Figure 16 Relationships between quantities of chloride ions and solid-phase and adsorbed chlorides (effects of replacement of cement with ground granulated blast furnace slag)

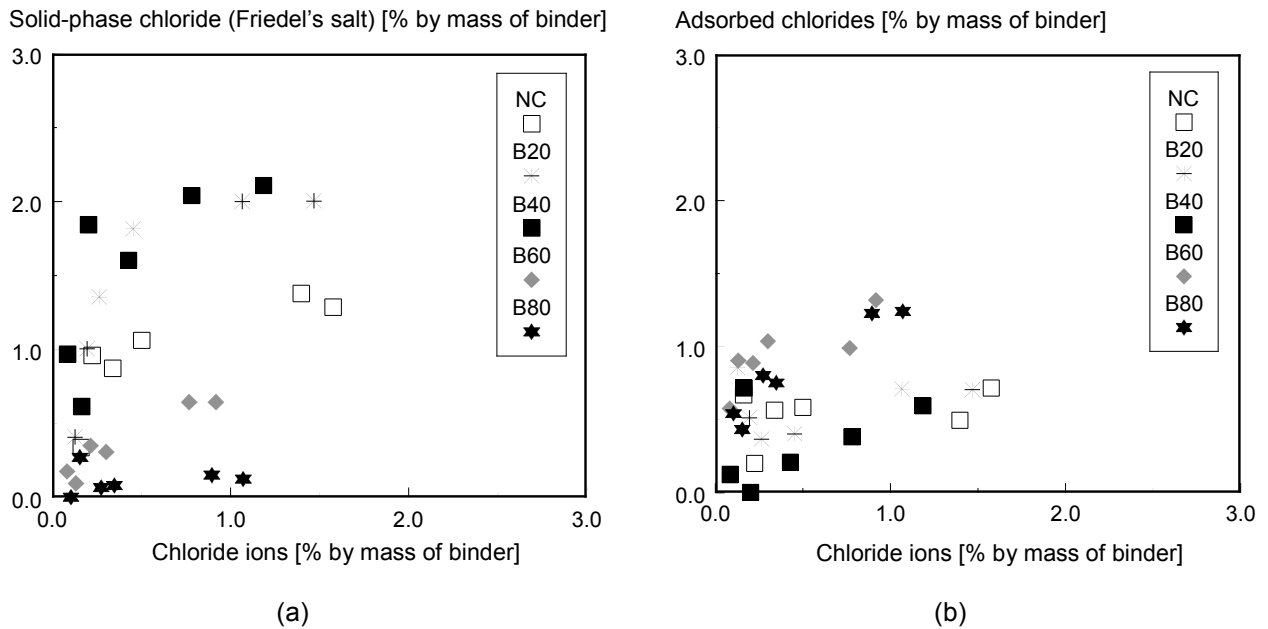
NC data in Figs. 12(b), 16(b), 19(b) and 22(b) should read as that shown in Fig. 10(b).

B20 data in Figs. 16(a) and (b) are improperly plotted. Revised figures are given below.

Figure 18 Chloride binding capacity of mortar using fly ash

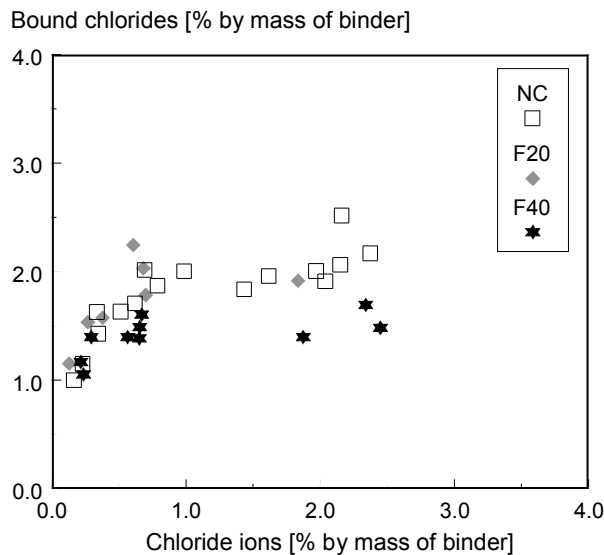
F20 data in Fig. 18 are improperly plotted. Revised figures are given below.
